Access Compliance Report Public Rights-of-Way (Curb Ramps)

Intersection ID: N/A Main Street: S CALDWELL ST Cross Street: E_STONEWALL_ST Location: NW ADA ID: 2F1C561F5BD1 Ramp Type: Perp Initial Pass/Fail: Pass **Overall Compliance: No Severity Score:**

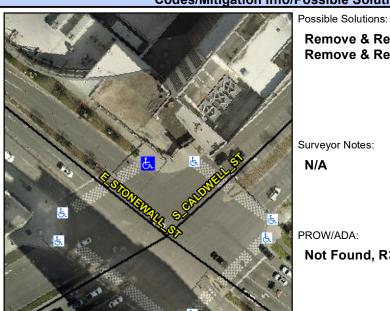
PROW/ADA: Not Found, R304.5.3 Total Cost: 2600.00

Remove & Replace Entire Ramp. Remove & Replace Gutter.
